# BEFORE

Gap observed after tightening of matting part or Matting part not answering till groove end

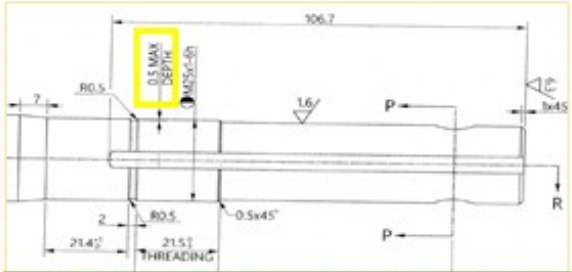
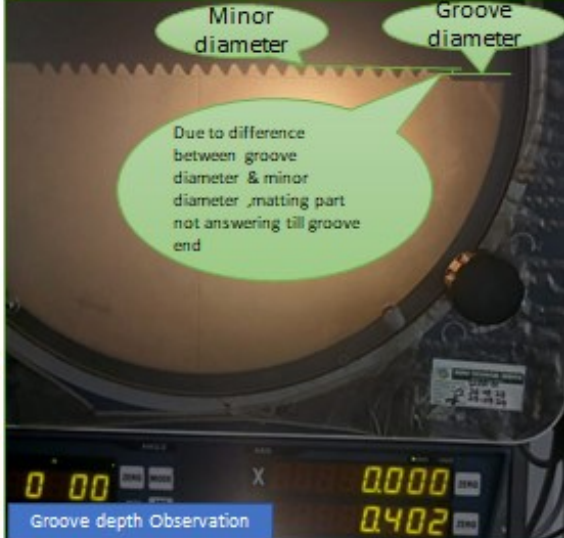
As per steering shaft Drawing ,grove depth should be 0.5Max depth from the major diameter of M24x1-6h thread

Sr. N.	Parameter	Specification	Observation	Remarks
1	Major diameter of M25 thread	24.97~24.79	24.879	OK
2	Minor diameter of M25 thread	23.583~23.891	23.657	OK
3	Groove depth	0.5Max	0.402	Ok
4	Major diameter minus twice of Groove depth (Groove Diameter)	As per calculation ( 24.879-0.402-0.402)	24.075	Groove diameter is more by 0.418 from minor diameter , by which matting part not answering till groove end.

**Conclusion:-**  
If matting part is to be a nswer till groove end then groove diameter should be less than the minimum specification of the M25x1-6h thread minor diameter.
